SYDNEY NORTH PLANNING PANEL COUNCIL ASSESSMENT REPORT

Panel Reference	2018SNH042
DA Number	DA2018/1166
LGA	Northern Beaches Council
Proposed Development	Demolition Works and Construction of a Boarding House development made pursuant to State Environmental Planning Policy (Affordable Rental Housing) 2009
Street Address	Lot A DP 400997, 613 Pittwater Road, Lot 8 DP 22384, 615 Pittwater Road, and Lot 2 DP 22384, 11 May Road, Dee Why
Applicant	Leech Harmon Architects
Owner	Adam Jon Tesoriero
Date of DA lodgement	6 July 2018
Number of Submissions	68
Recommendation	Refusal
Regional Development Criteria (Schedule 7 of the SEPP) State and Regional Development) 2011	Development with a Capital Investment Value (CIV) of more than \$5 million for affordable housing (which includes Boarding House)
List of all relevant s4.15(1)(a) matters	<ul style="list-style-type: none"> • Environmental Planning and Assessment Act 1979 • Environmental Planning and Assessment Regulation 2000 • State Environmental Planning Policy No. 55 – Remediation of Land • State Environmental Planning Policy (Building Sustainability Index: BASIX) • State Environmental Planning Policy – Infrastructure 2011 • State Environmen

Figure 2 – Proposed building arrangement. (Source: Adapted by the author from Plan No. DA-01, dated 5 July 2018 and prepared by Leech Harmon Architects)

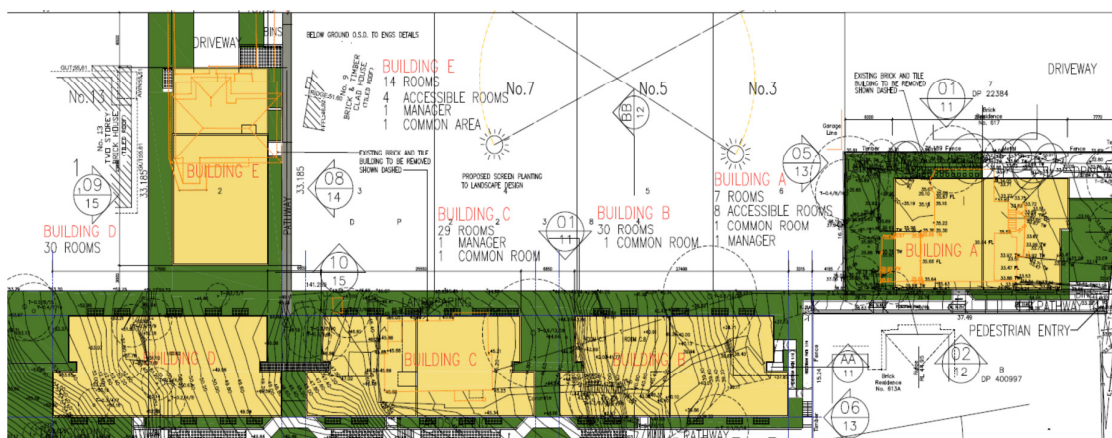
The applicant proposes to demolish all existing on-site structures and construct five (5) three storey buildings spread across the three (3) Lots over a split level basement car park, which accommodates 125 boarding rooms, including 12 accessible rooms and 3 manager rooms. The development includes landscape works and communal areas.

Figure 1 below is provided to assist in the identification of the proposed buildings within the site.
